Potential deviation from IEEE802-1AS-REV (Draft D8.0) end-to-end performance

Amin Abdul
Molex Canada

June 2019

IEC/IEEE 60802 D1.0 (table 13 and 14) end-to-end time-synchronization performance – Working Clock

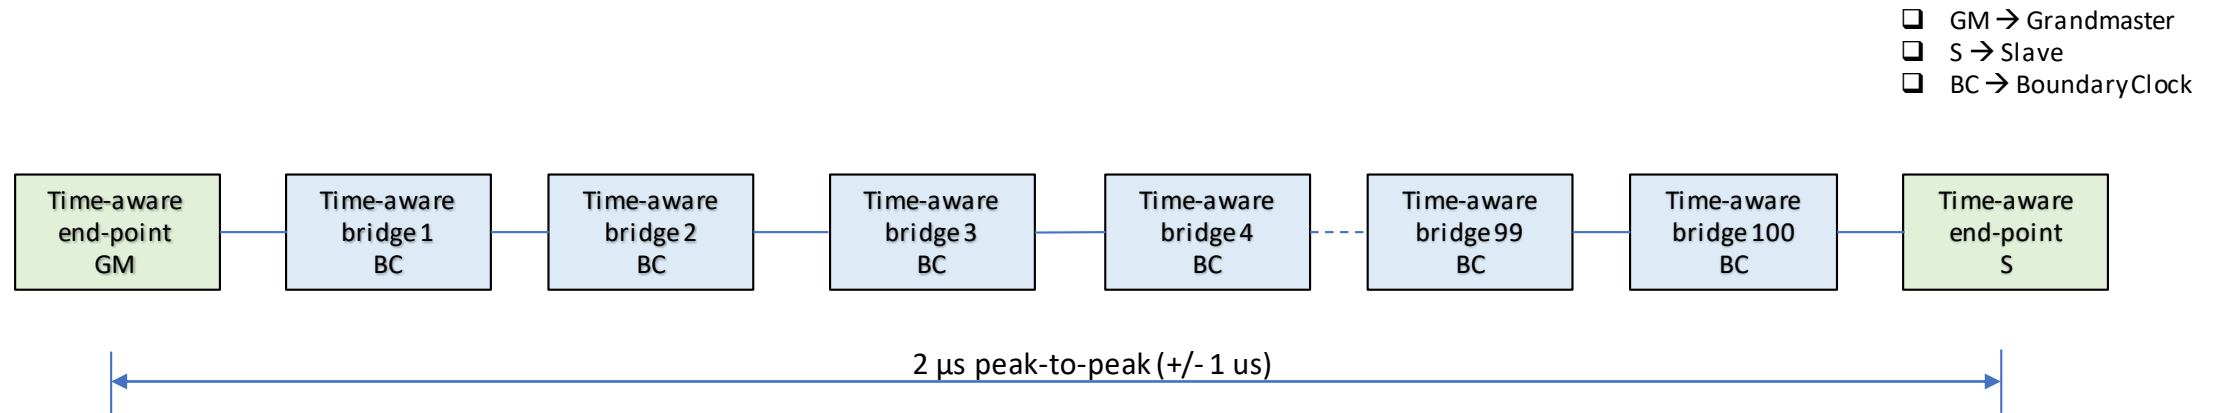
- Table 13 – Working Clock maximum deviation within $2 \mu\text{s}$ ($\pm 1 \mu\text{s}$)
- Notion of PTP **steady-state** operation is missing
- It seems that, in the context of IEC/IEEE 60802 the number of hops represents number of time-aware bridges, not the number of PTP Communication Paths.

IEEE802.1AS-REV impact on network start-up time

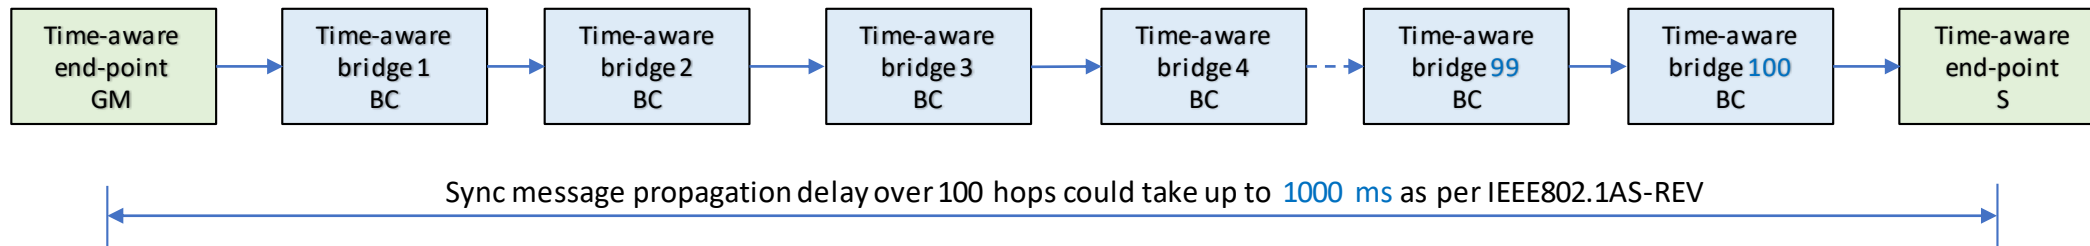
- Propagation delay per time-aware bridge
 - IEEE802.1AS-REV D8.0 Annex B.2.2: Residence time → up to 10 ms
 - IEEE802.1AS-REV D8.0 Annex B.2.3: Pdelay turnaround time → up to 10 ms

- There is a correlation between the time required to achieve the network steady-state and network span
- Some automation applications may need tighter constraints on Residence time and Pdelay turnaround time to improve network convergence time
